#### IN THE DRAWINGS

#### REMARKS

## Amendments to the Drawings

#### Fig. 2

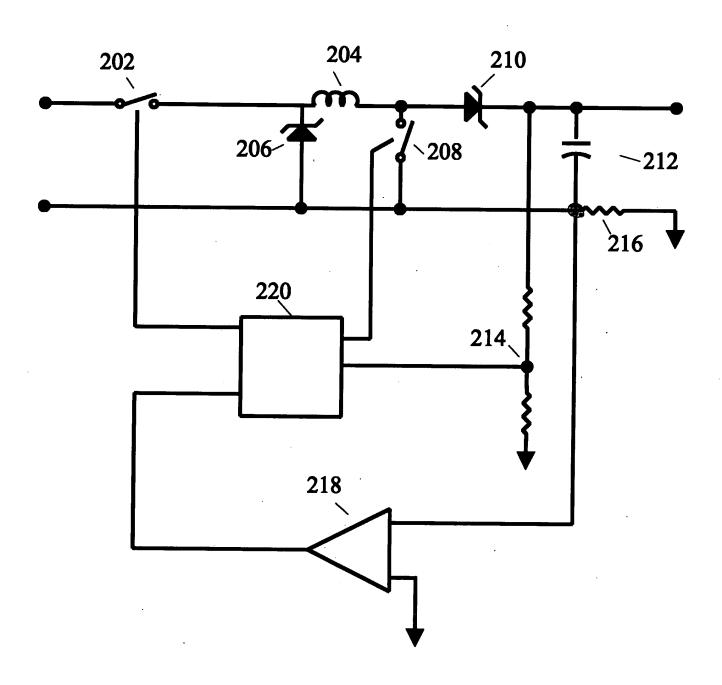
The junction of the wire connected to resistor 216 and the wire connected to capacitor 212 has been clarified by addition of an enlarged dot indicating that the branches are connected.

First, in Figure 2, the junction of the wire connected to resistor 216 and the wire connected to capacitor 212 has been clarified by addition of an enlarged dot to more clearly indicate that the branches are connected. Second, in Figure 5, the junction of the wire connected to motor 406 and the wire connected to capacitor 418 has been clarified by addition of an enlarged dot to more clearly indicate that the branches are connected.

Support for the amendment to Figure 2 appears, for example, in paragraph 0036, which indicates that "current sense resistor 216 and amplifier 218 ... provide feedback to circuit 220 of output current." It is respectfully submitted that one skilled in the art would readily understand that a circuit path is needed from current sense resistor 216 to amplifier 218 for such operation to occur, and would readily understand from inspection that the branches identified above would be interconnected in order to make such a circuit path.

### Fig. 5

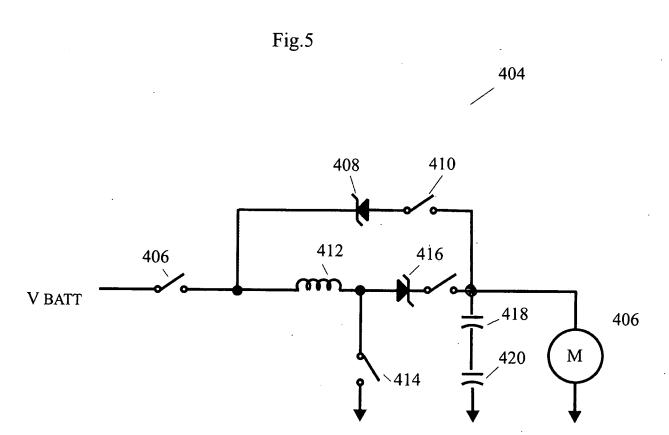
The junction of the wire connected to motor 406 and the wire connected to capacitor 418 has been clarified by addition of an enlarged dot indicating that the branches are connected.

Support for the amendment to Figure 5 appears, for example, in paragraph 0058, which indicates that "[c]apacitors 418 and 420 filter the output to remove ripple from the output voltage." It is respectfully submitted that one skilled in the art would readily understand that a circuit path is needed from voltage output to capacitor 418 for such operation to occur, and would readily understand from

inspection that the branches identified above would be interconnected in order to make such a circuit path. While such connection is understood in original Figure 5, the addition of the enlarged dot merely confirms such a connection.
